CHANGE ORDER

Project Name: **Haverhill Consentino Middle School** CO No. **12**

See attached list of 2 item(s) for a total of.....\$26,209.67

CCD / PR / PCO #	Description	Amount
PCO 94 R1	Area C Ceiling Rated Ceiling	\$ (586.35)
PCO 72 R1	Hellerup Stair Materials	\$26,877.02
Total		\$ 26,290.67

JD-104R1

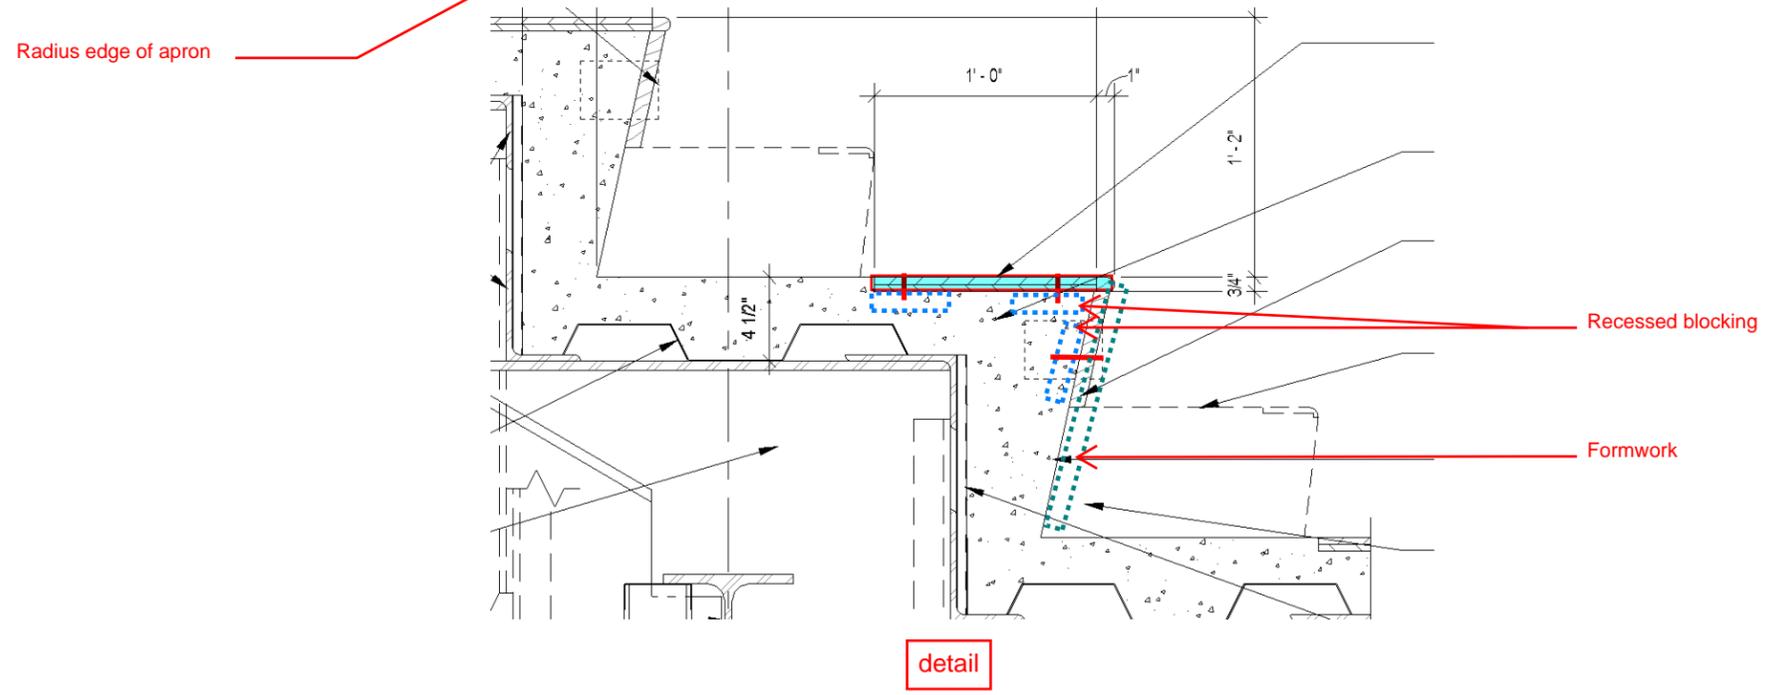
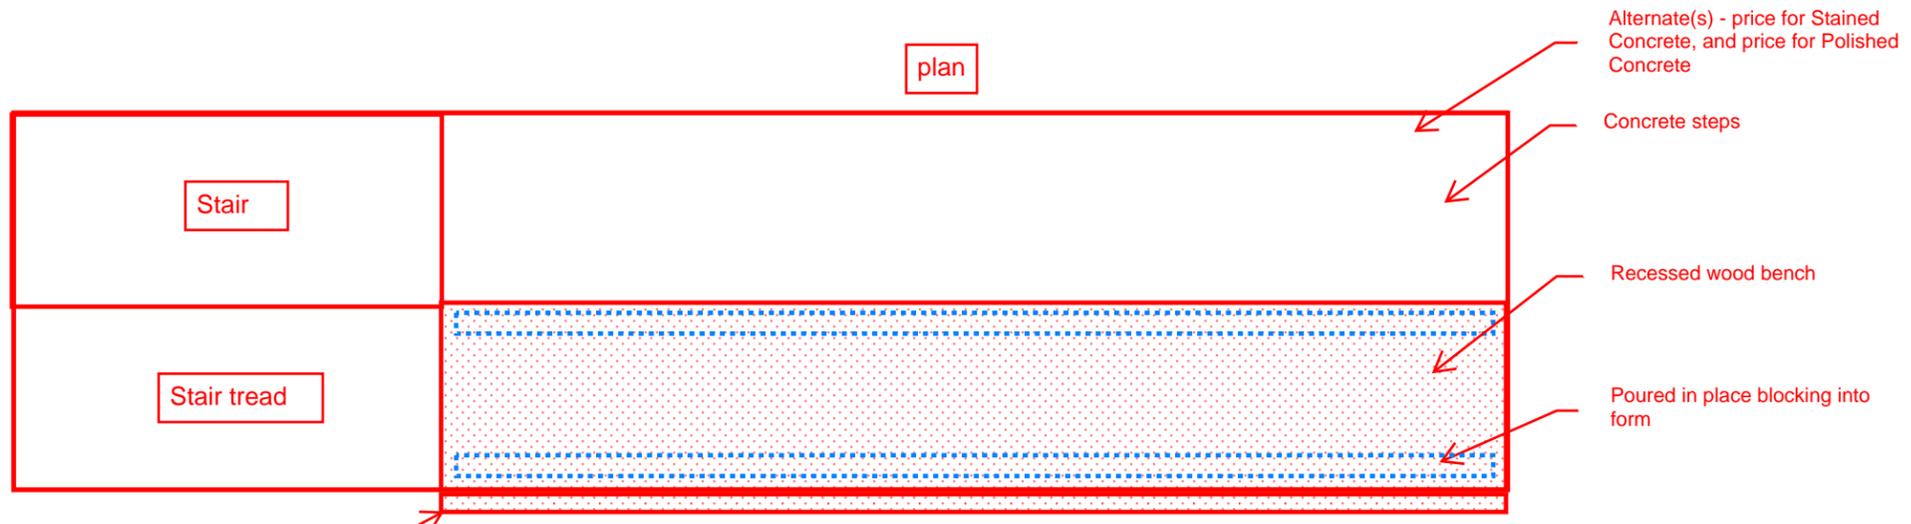
At Sheet A7.51, for the cafetorium heller up stair, replace the "3/4" VENEER PLYWOOD SEAT W/ HDWD EDGE BAND" with "1" SOLID MAPLE, INCLUDING RADIUSSED EDGE". ~~Wood seating to be held back 12" from stair treads at each row.~~ Revise seat attachment and embedded blocking as shown on attached sketch **JD-104R1** for proposed recessed blocking. Wood apron to be radiussed at stair riser.
